RE: Greenspot Wetherill Park – SSD 7401 – Response to comments

I make reference to your email comments received on Thursday 19 October 2017 for the abovementioned project proposed by Bettergrow. The following information seeks to address the comments provided by the Department and resolve any outstanding information requests.

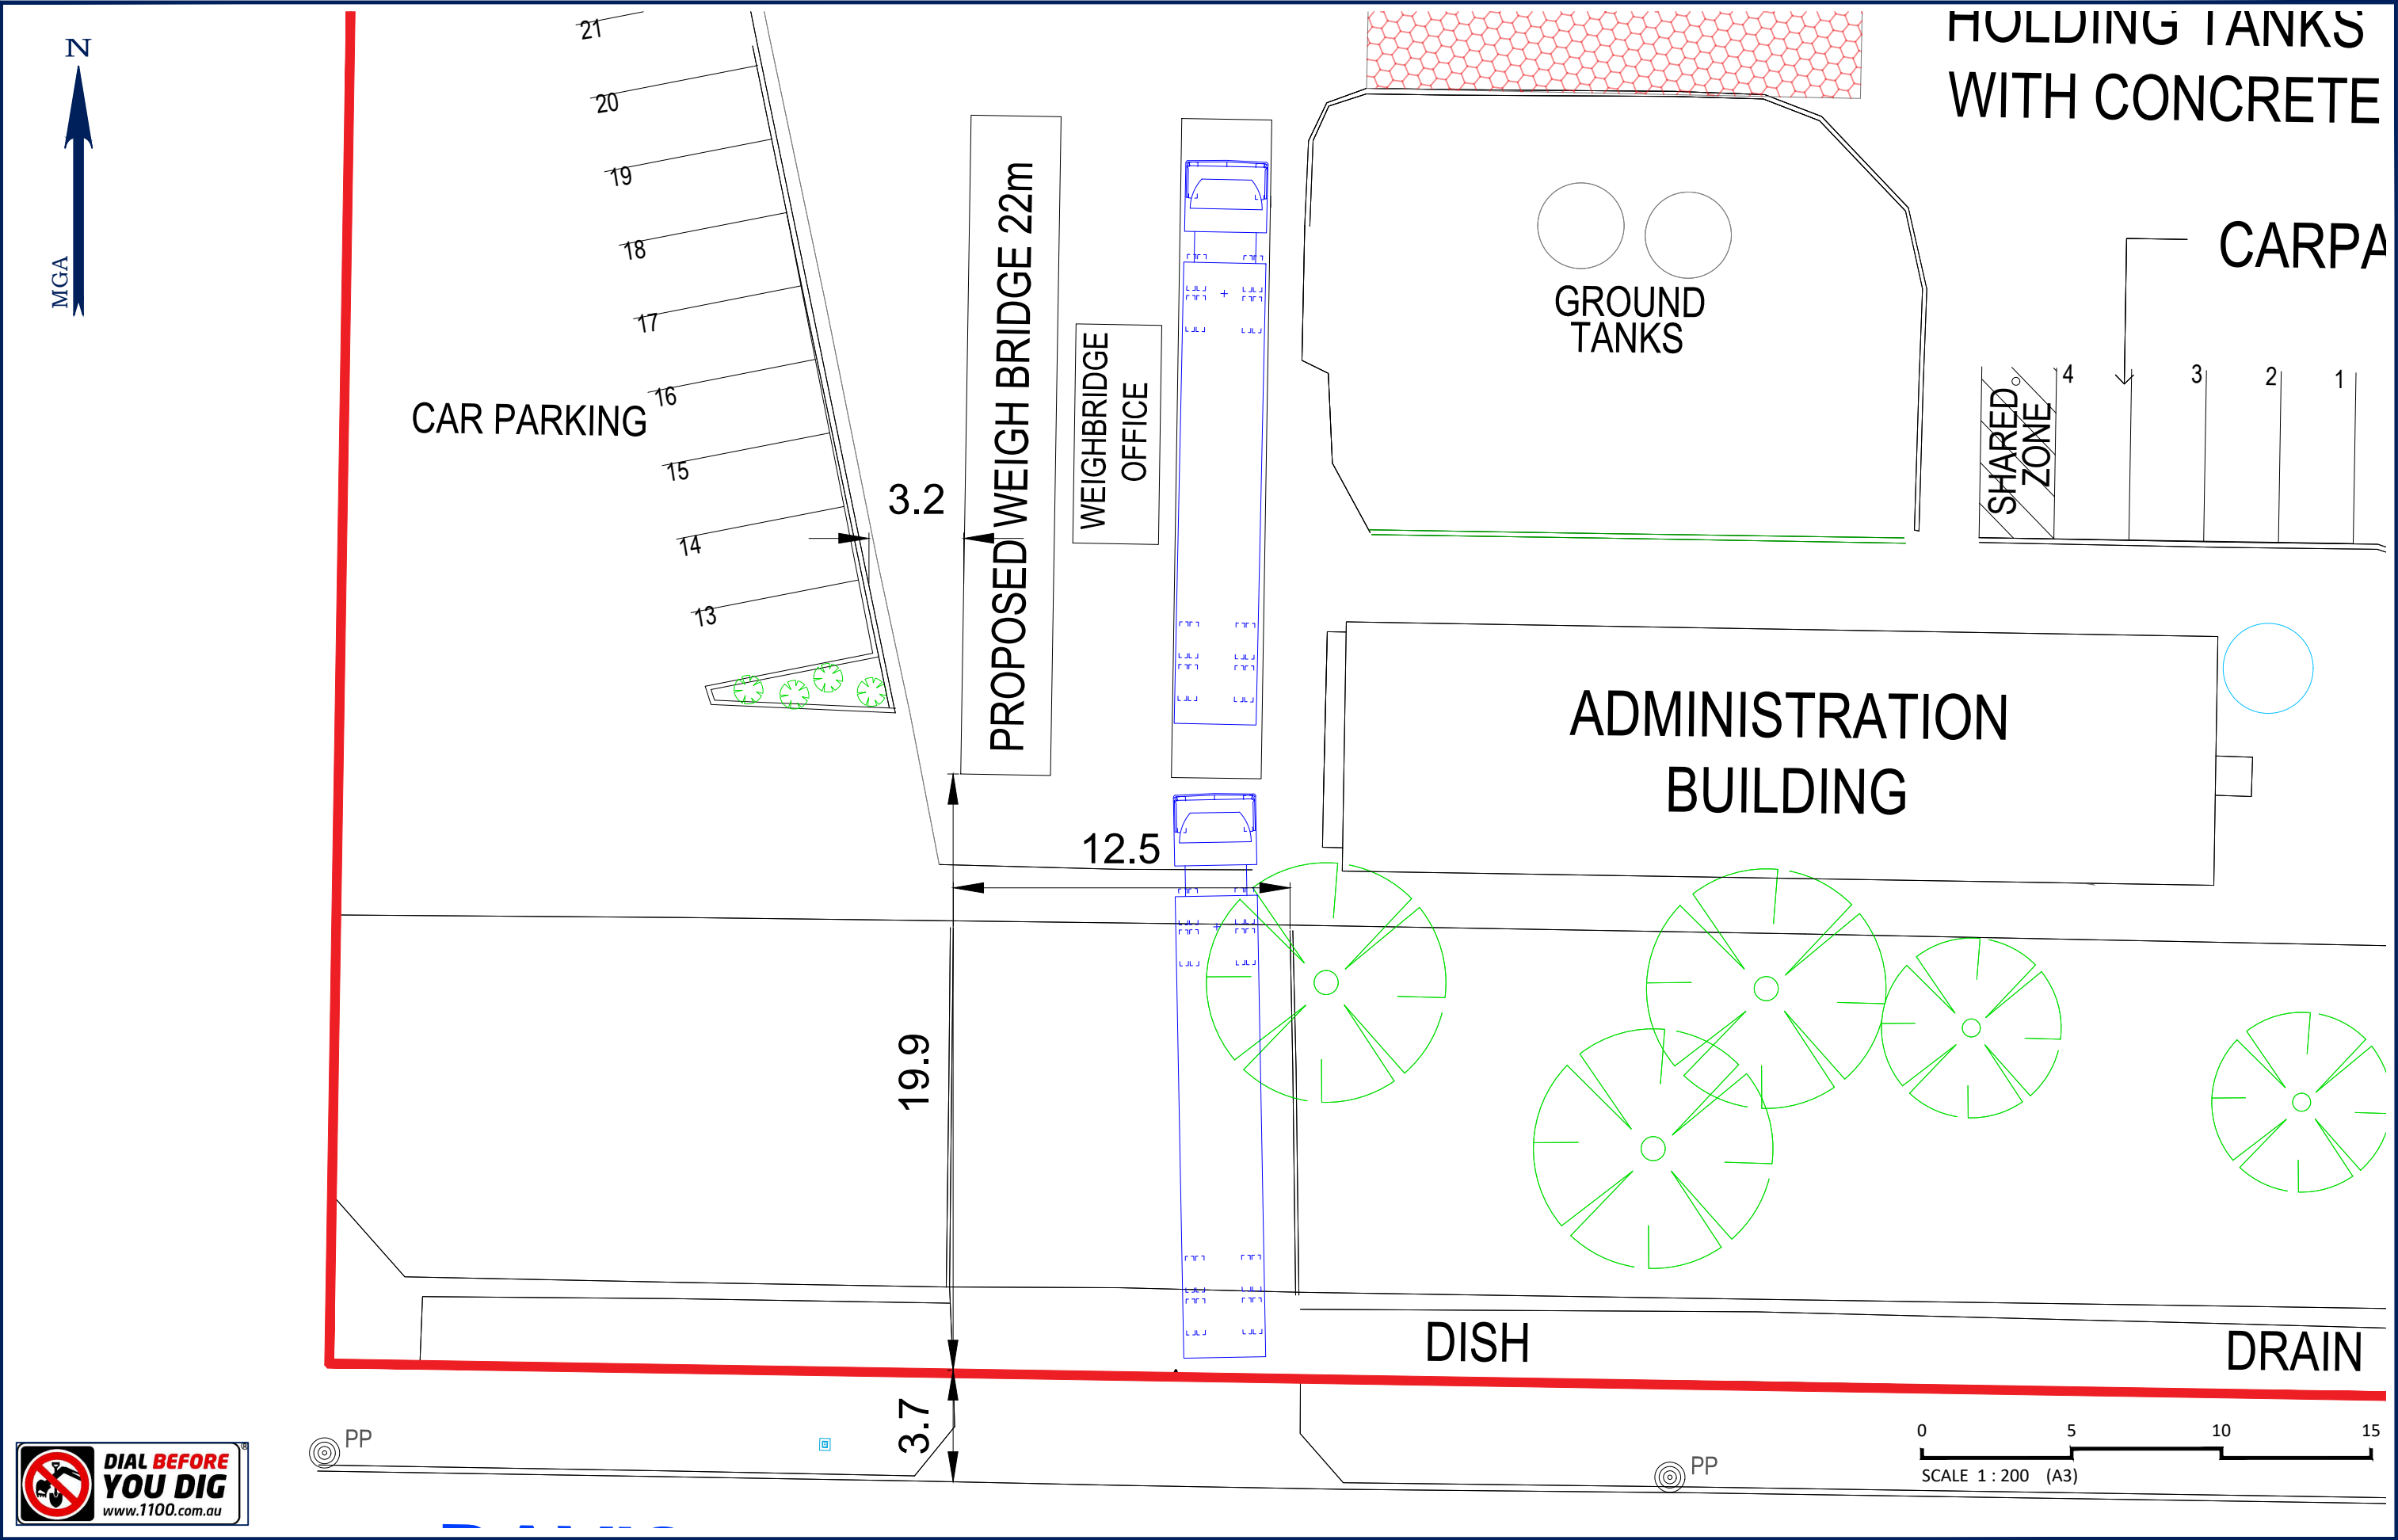
5. Please demonstrate that the facility will not result in queuing along Davis Road during peak times. This should include a plan showing how many heavy vehicles can be accommodated on the site, how long the weighbridge process takes and how long it takes for vehicles to enter/exit the site and further details on how the queuing impacts will be managed.

In order to prevent the queuing of trucks outside of the site boundary the following will be implemented:

- Average transaction time on the incoming weighbridge estimated to be 2 minutes;
- Provision of separate incoming and outgoing weighbridges; and
- Design allows for one truck on the weighbridge with one 19m B-Double parked ready to enter (or 2 medium rigid vehicles 8.8m long each) without queuing over the nature strip or onto the roadway.

The following figure has been prepared showing the dimensions of the proposed heavy vehicle access, the weighbridges, and the queuing of 19m B-Double trucks on the weighbridge and one truck waiting to enter.

Figure 2 from the Traffic Impact Assessment prepared by Thompson Stanbury (below) shows the weekday peak hour traffic volumes between 7:00am-8:00am and 4:00pm-5:00pm.

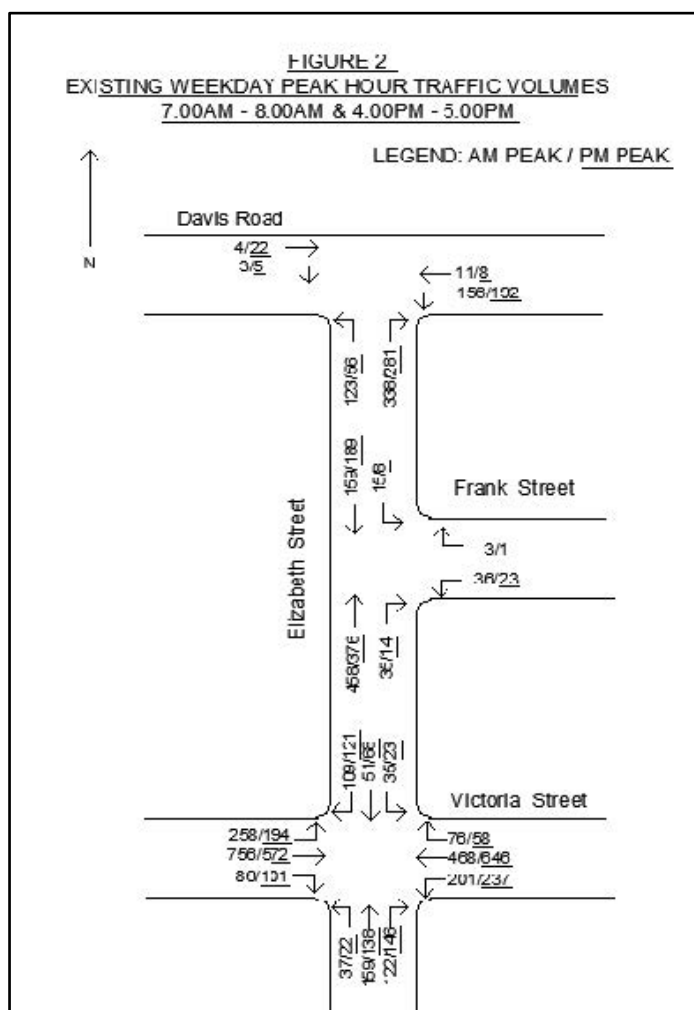
6. Please provide further details as to why traffic modelling from 4pm-6pm was considered appropriate. The Department notes that Council has requested modelling be conducted from 3pm-4pm.

On comparison of the traffic counts undertaken by Thompson Stanbury and PeopleTrans (2016) it was found that they are generally the same for both the AM and PM periods for both assessments. Further, the counts for the 4:00pm-5:00pm period undertaken by Thompson Stanbury and the 3:00pm-4:00pm period undertaken by PeopleTrans (2016) are also generally the same. Therefore there is no significant difference in traffic volumes during these periods.

This would indicate that the traffic counts undertaken by Thompson Stanbury for the Bettergrow EIS during the 4:00pm-5:00pm period are relevant and accurate for the assessment undertaken.

The figure below is extracted from the Surface Water Assessment prepared by Northrop. Shown on the figure is the location a gate valve which will be installed to isolate the site surface water system from the Council stormwater system.

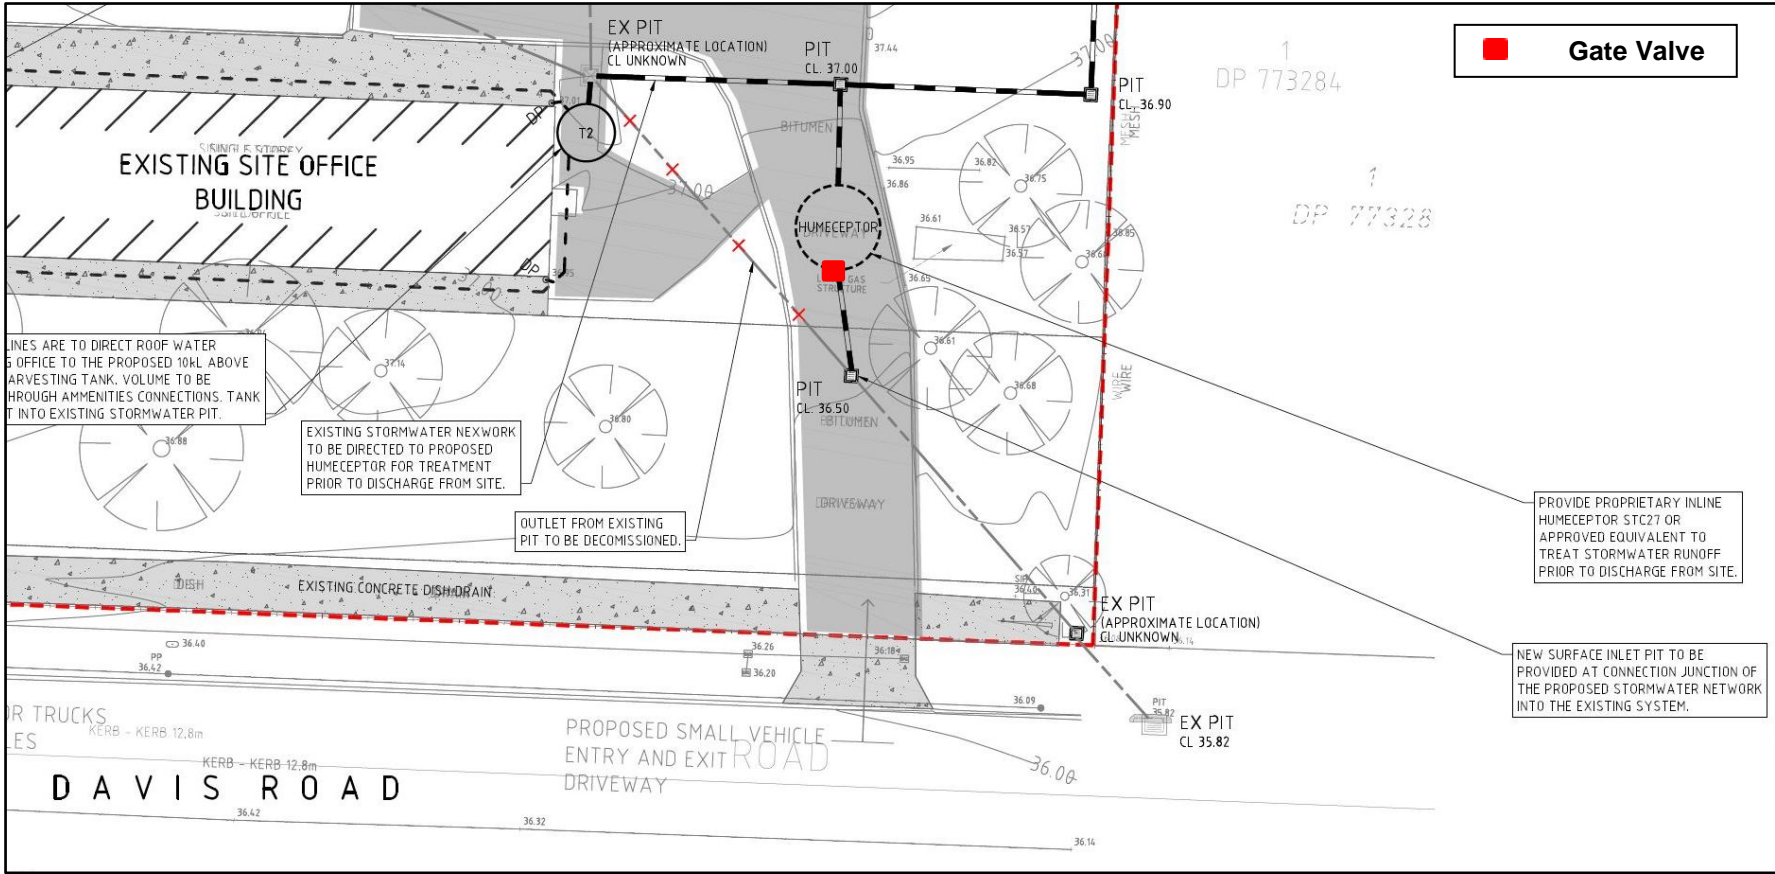
9. Please detail how external fire water would be managed.

Should a fire occur at the site, all fire water generated external to the processing buildings on the upper level will be captured and managed through the ability to isolate the site stormwater system from the Council stormwater system. The site stormwater system includes a sediment trap in the bulk landscape area with a capacity of 41kL. From the sediment trap the system then connects with a secondary treatment device (Humeceptor STC-27) that will have a capacity of 27kL. The entire system will have the ability to be shut off from the external street system by way of a gate valve on the outlet side of the Humeceptor. The two treatment devices will act as containment for fire water in the event of a fire.
